寄件者: TsangShun Qi <[REDACTED]>  
寄件日期: 2026年04月08日星期三 15:30  
收件者: Adrian Tsz Hin TAM/PLAND  
主旨: 回复 : Planning Application No. A/NE-TKLN/125 --- Temporary Warehouse for Storage of Electric Cable with Ancillary Open Storage of Construction Materials for a Period of 3 Years  
附件: TD proposal 1.pdf; response to TD comment.pdf  
類別: Internet Email

## A/NE-TKLN-125, Response to comments

### Transport Department (TD)

# Traffic Impact Proposal

**Table 2.4 Current traffic flow in Lin Ma Hang Road (Survey point show in Figure 1.1)**

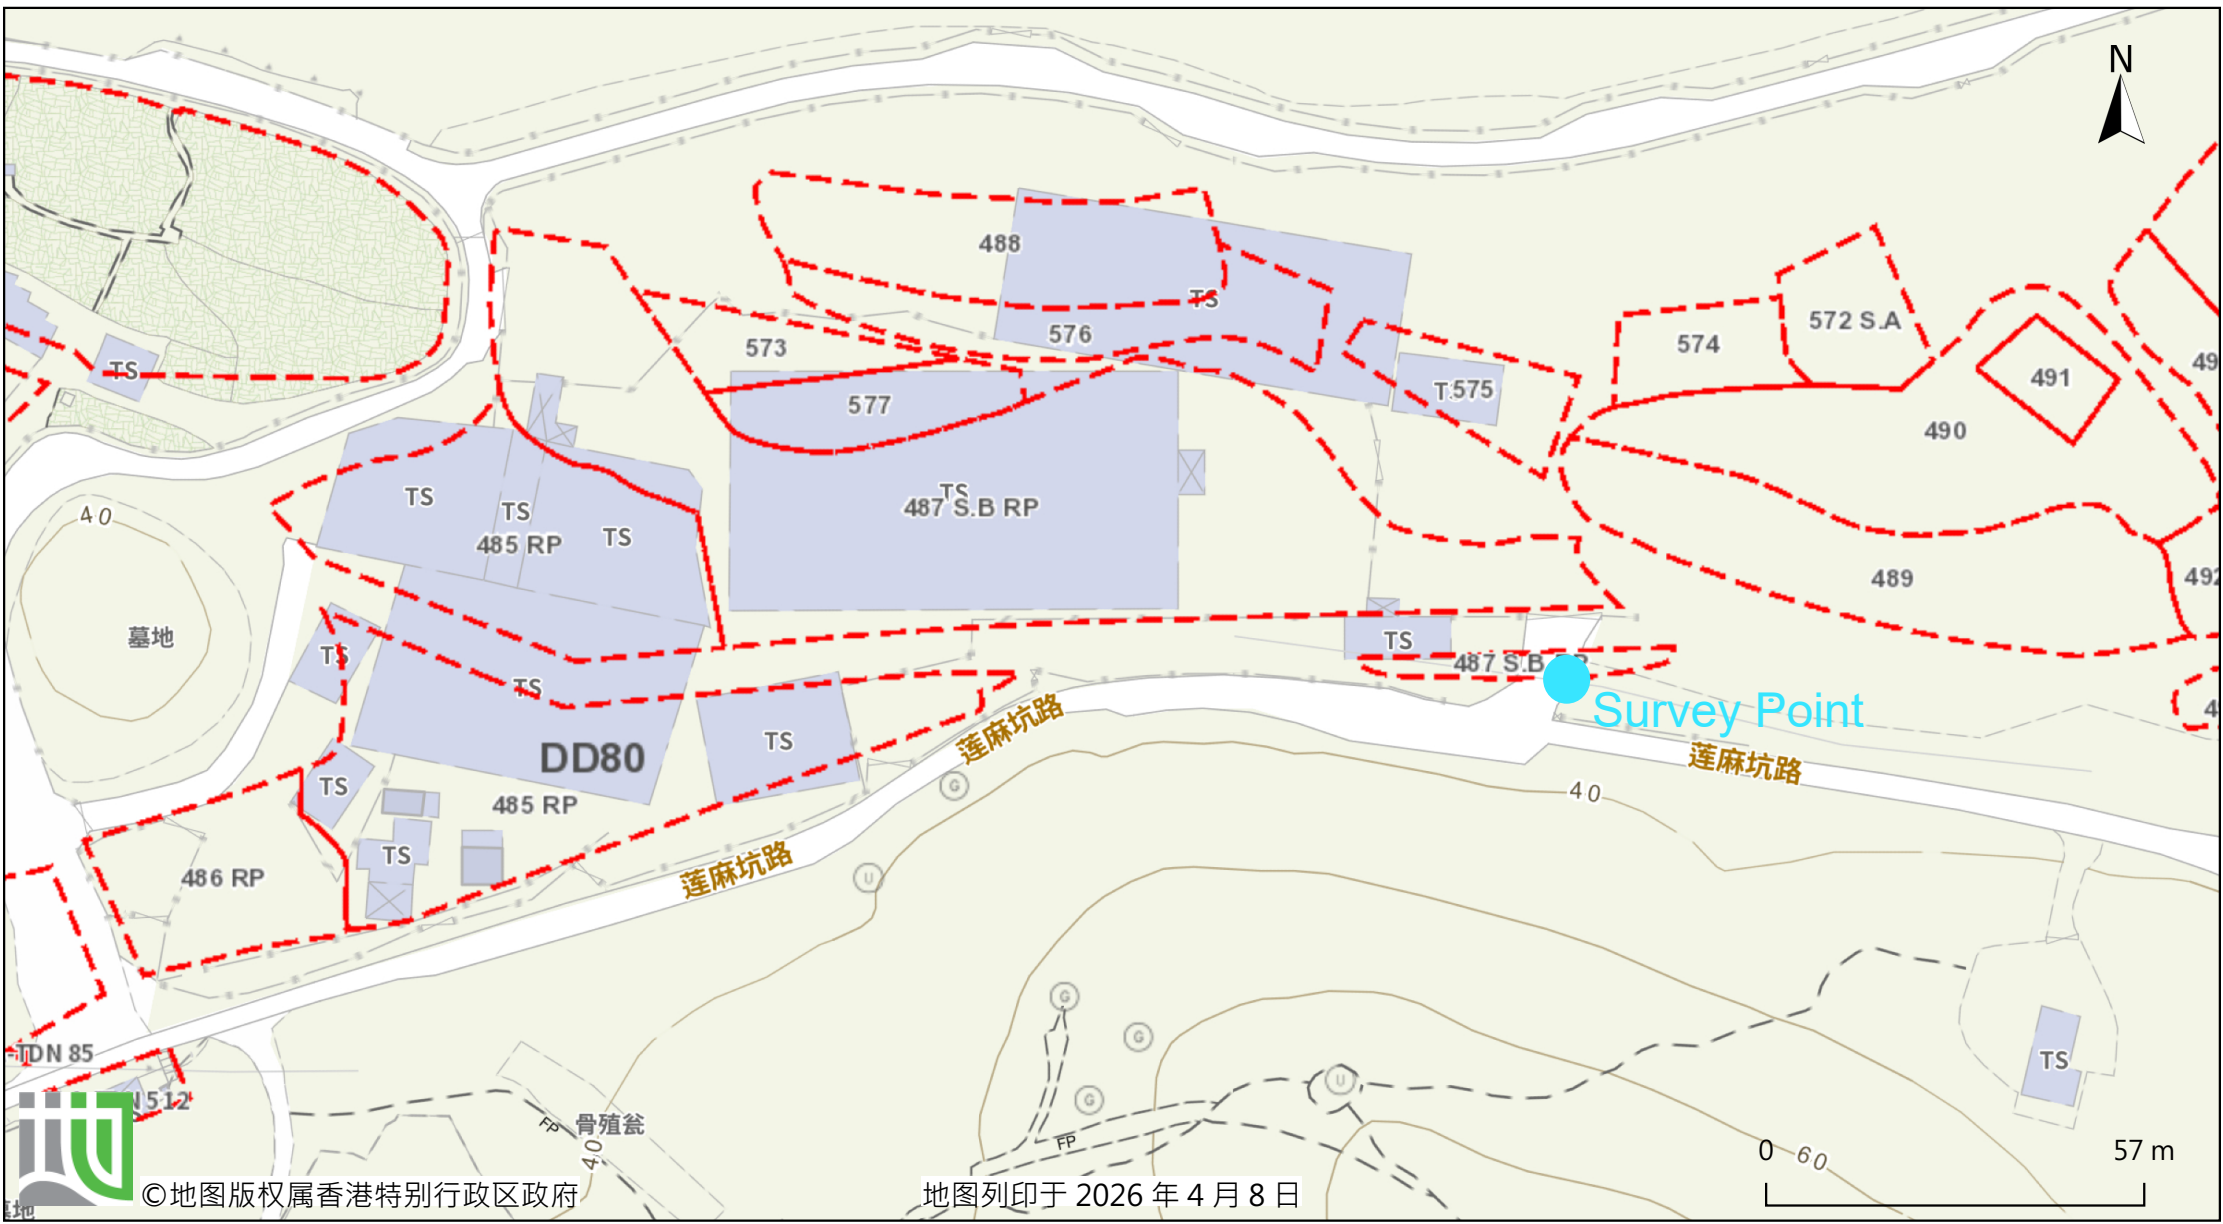
<b>Comment 1</b>
the applicant should advise and substantiate the traffic generation from and attraction to the subject site and the traffic impact to the nearby road links and junctions;
<b>Response</b>
<p>The proposed use of the subject site is for temporary open storage of metal scaffolding with an ancillary office, which is not expected to generate significant traffic. Only two medium goods vehicle (MGV) loading and unloading parking spaces will be provided, which are sufficient to meet the daily operational needs.</p> <p>A traffic impact proposal is provided to estimated traffic generation.</p>

Friday: Total vehicles: 74 (8 hours), average 10 vehicles/hour.

Saturday: Total vehicles: 64 (8 hours), average 8 vehicles/hour. Comparison: Traffic flow on Saturday and Friday (approximately 15%). This is likely due to increased commuter traffic on weekdays.

The additional traffic increase from Dubai development is only about 1 vehicle/hour. No significant traffic congestion, nighttime congestion, or service level decline is expected in the near future. The current situation is unfavorable and will not have any significant adverse impact on the additional traffic volume or service level on Lin Ma Hang Road
